# A47 Wansford to Sutton Dualling

## **9.32 Applicant's Response to the Examining Authority's Third Written Questions (ExQ3)**

**9.32 APPLICANT'S RESPONSE TO THE EXAMINING  
AUTHORITY'S THIRD WRITTEN QUESTIONS (EXQ3)**

<b>Rule Number</b>	Rule 8(1)(c)
<b>Planning Inspectorate Scheme Reference</b>	TR010039
<b>Application Document Reference</b>	TR010039/EXAM/9.32
<b>BIM Document Reference</b>	PCF STAGE 4
<b>Author</b>	A47 Wansford to Sutton Project Team, National Highways

## **ANNEX B - Drawing HE551494-GTY-HGN-000-DR-CH-38004**

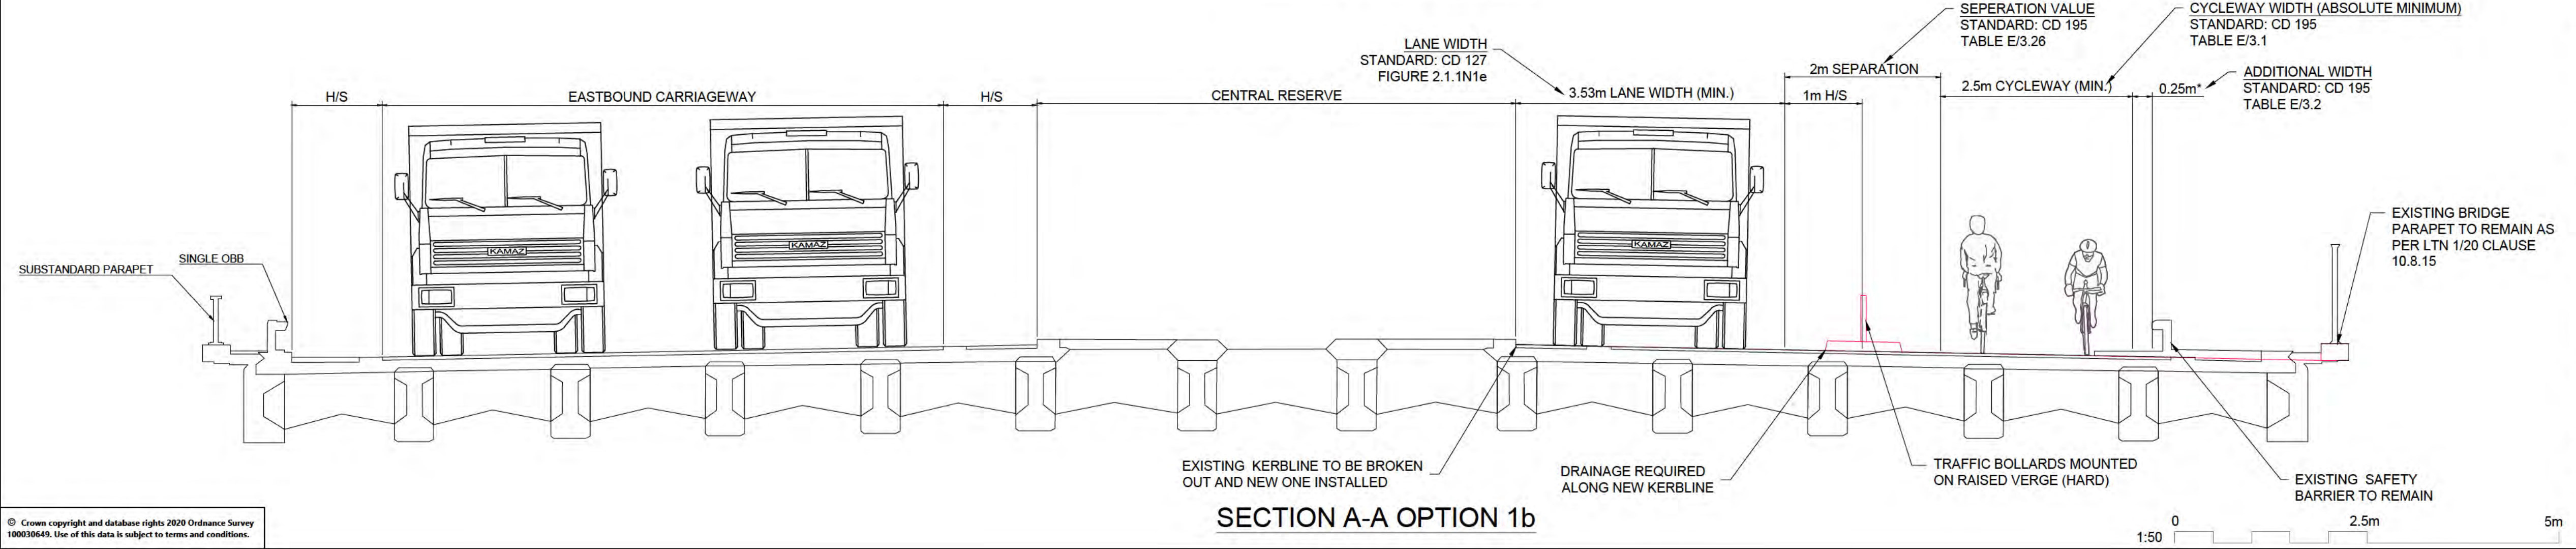
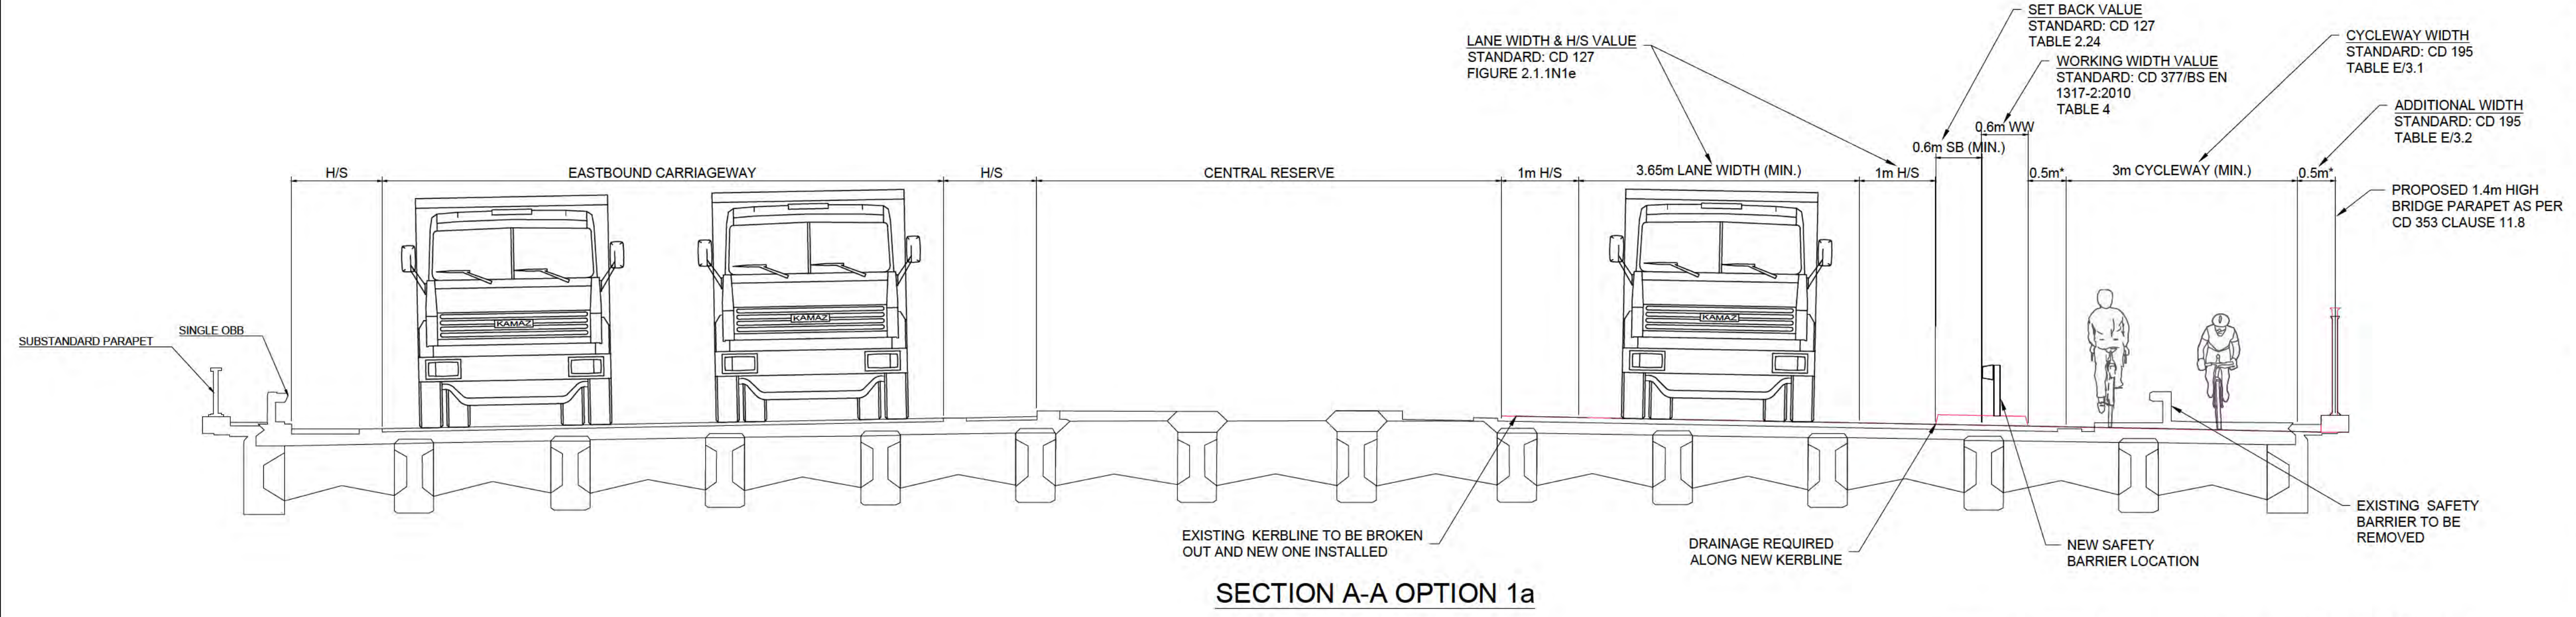
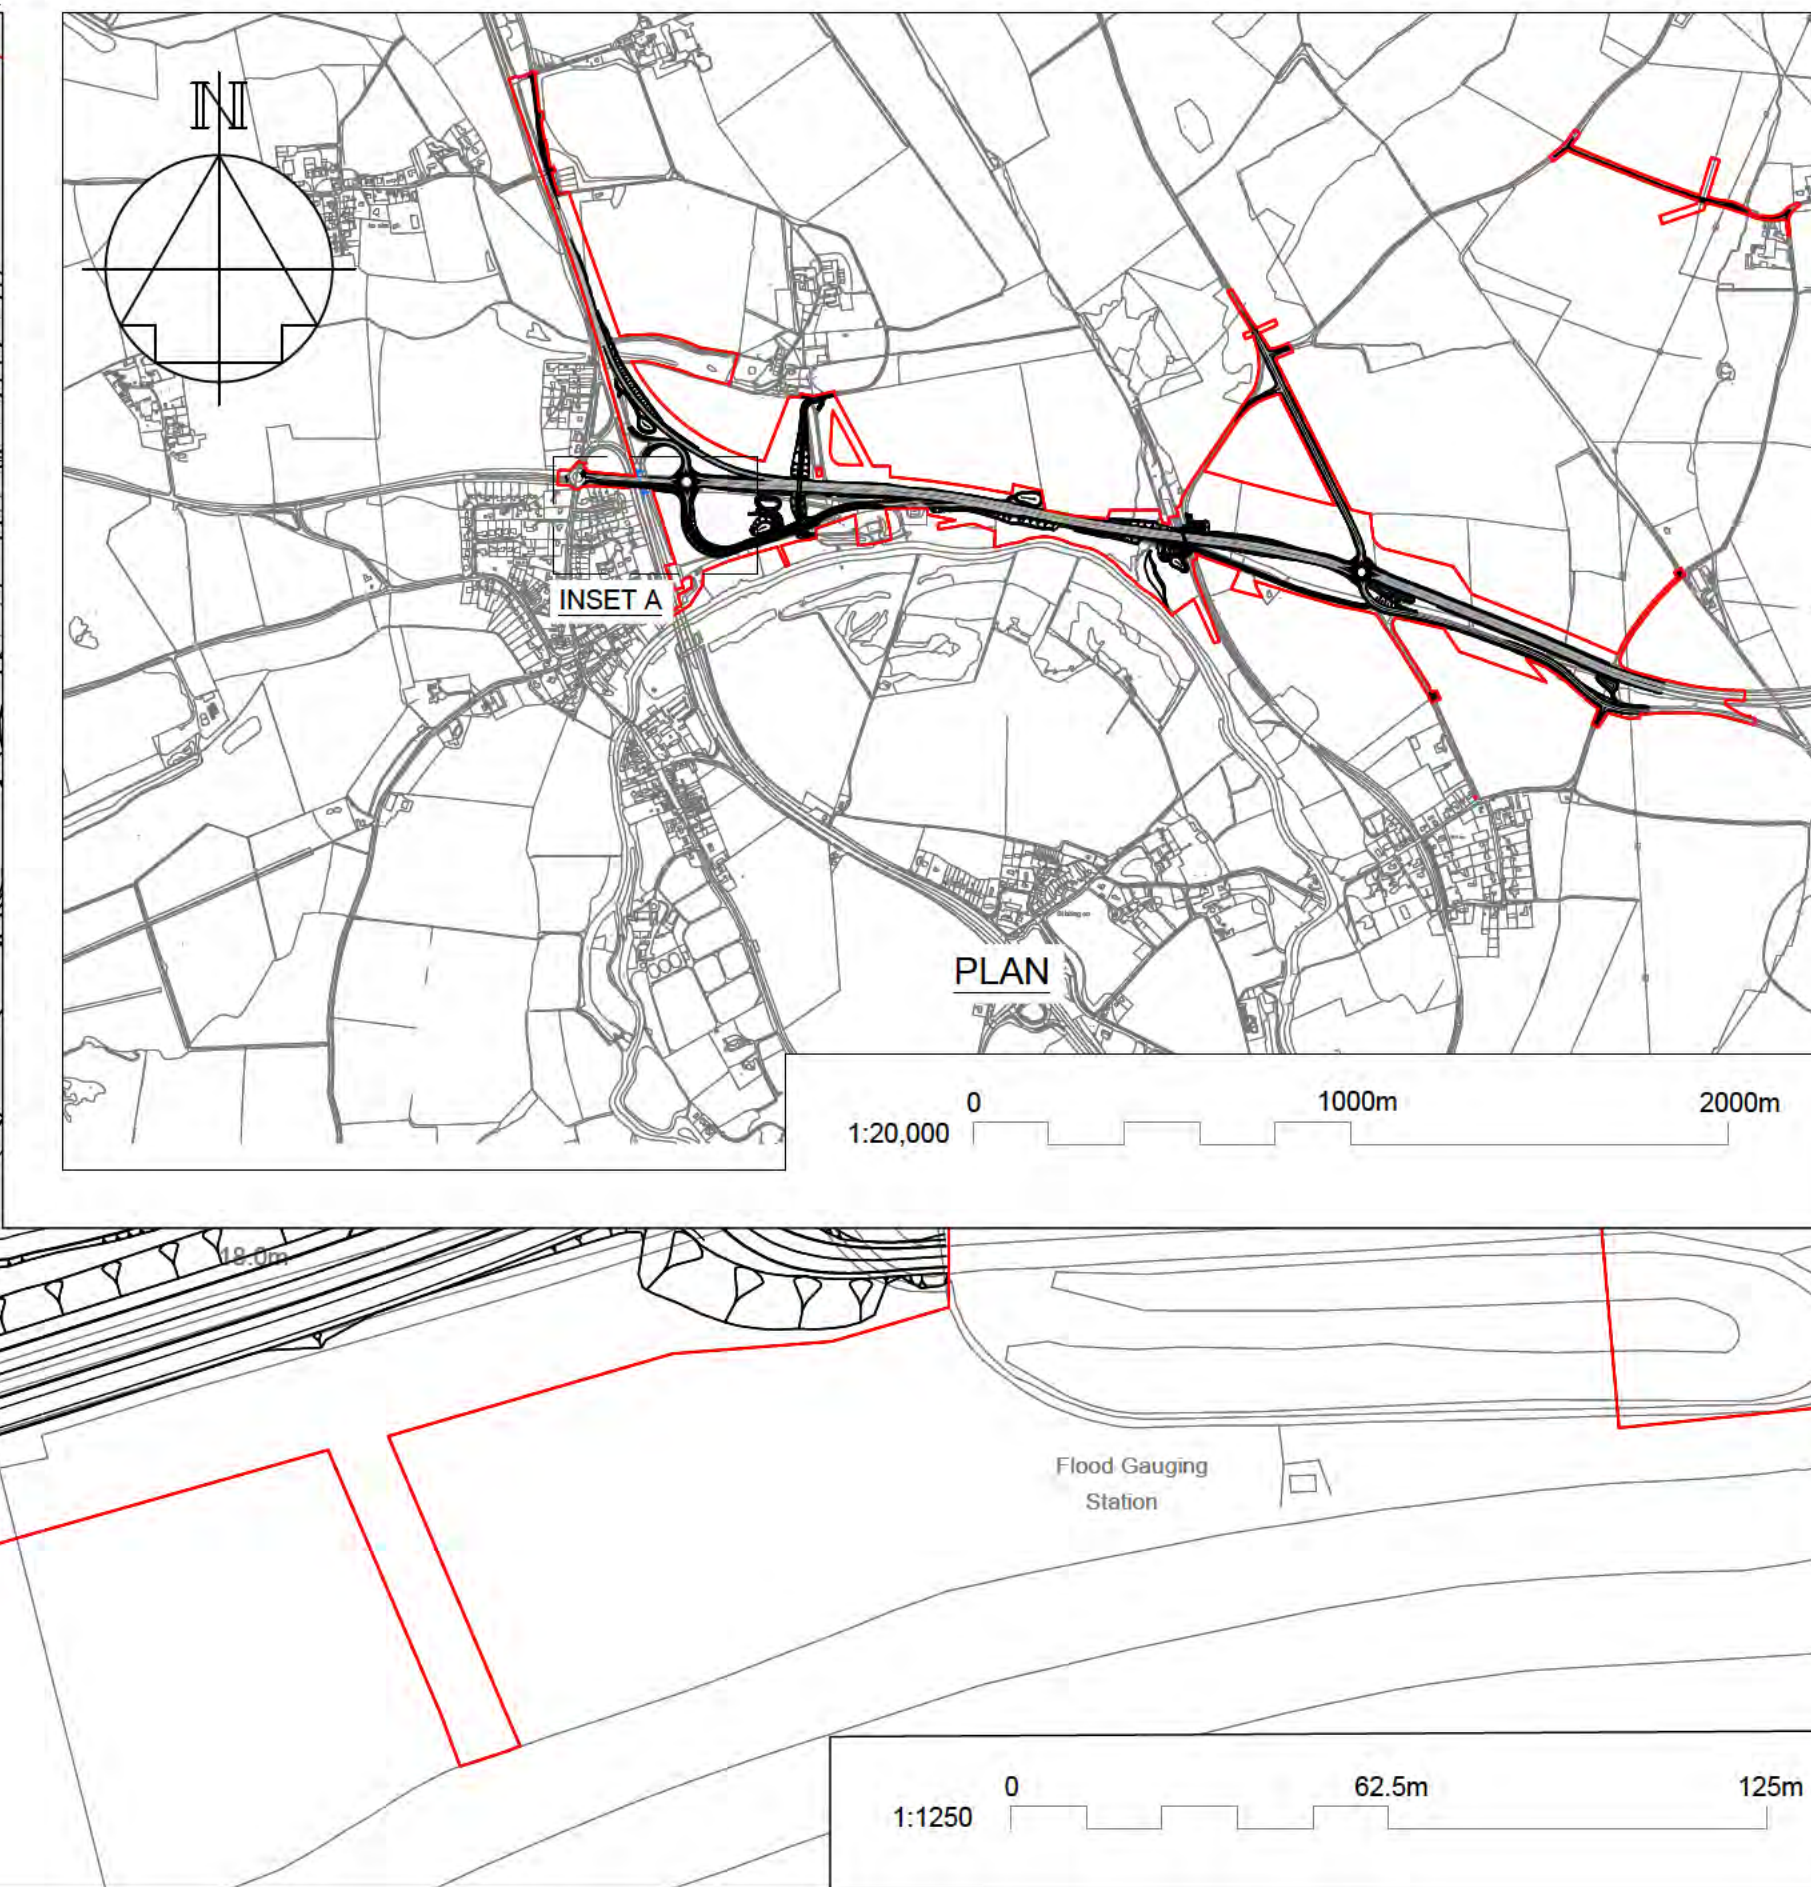
3.11.5	The Applicant	<p><b>NMU Route in southwest of Application site</b> In the Legal Note on Wansford Nene Way Permissive 1, the Applicant refers to Options 1a and 1b as shown on Drawing HE551494-GTY-HGN-000-DR-CH-38004. Could this drawing please be provided?</p>	This drawing has been provided as Annex B to this document.
<p><b>3.12 Water environment and flood risk</b></p>
